Fiat Punto (188) all models with air conditioning

Ingress of condensation water into the passenger compartment.

Bulletin

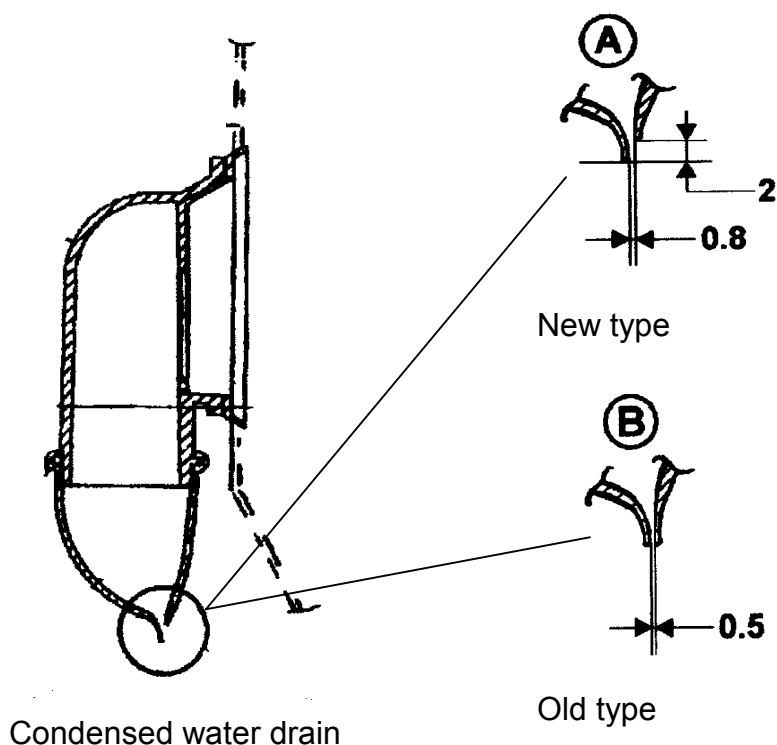
If, on this vehicle, the complaint is that condensation water ingress into the passenger compartment, a possible cause could be a blocked condense water drain.

To rectify the problem, the condense water drain on the fire wall must be renewed. The new condense water drain has the same part number as the original. The difference between the old and new one is the form (see drawings below).

Please compare the new with the old condense water drain before fitting to be sure that the problem does not recur.
